Project	<b>IEEE 802.16 Broadband Wireless Access Working Group</b> < <a href="http://ieee802.org/16">http://ieee802.org/16</a> >	
Title	<b>Restructuring of Clause 7 of 802.16e</b>	
Date Submitted	<b>[The date the document is contributed, in the format 2003-08-21]</b>	
Source(s)	David Johnston Intel Corporation Hillsboro, OR USA	Voice: 502 264 3855 Fax: <a href="mailto:dj.johnston@ieee.org">mailto:dj.johnston@ieee.org</a>
Re:	Comments 8007 and 8008 in sponsor recirculation of 802.16	
Abstract	A proposal, with specific text to restructure clause 7, making the editorial directions clear, accomodating both PKMv1 and PKMv2 and making the section numbers correct with respect to IEEE 802.16-2004 and corrigendum 1 so that it is possible to correctly amend the base document with the text into 802.16e.	
Purpose	Consider and adopt this text into the 802.16e draft as a resolution of comments 8007 and 8008.

## Restructuring of Clause 7 of 802.16e

The following text represents a complete replacement of the text of clause 7 in 802.16e. This is proposed as a resolution of comments 8007 and 8008 by the Editor, calling for clause 7 to be restructured since the document is inconsistent with the str

Figure 130j—Security sublayer

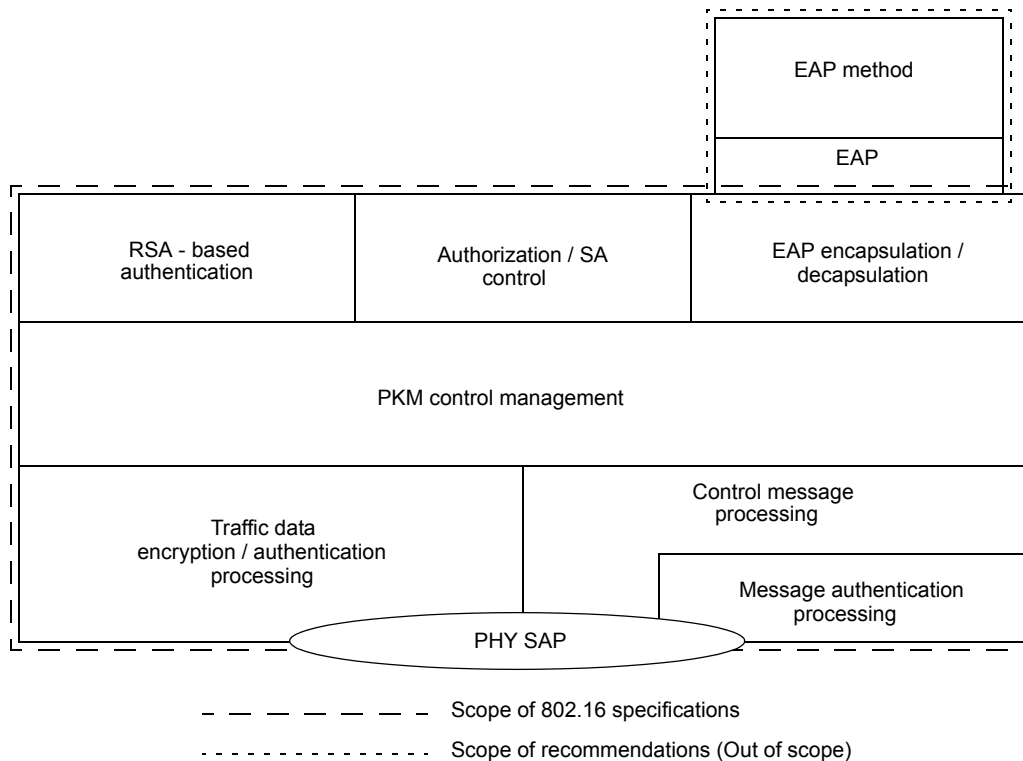
The protocol stack for the security components of the system are shown in Figure 130j.

*[Insert new figure:]*
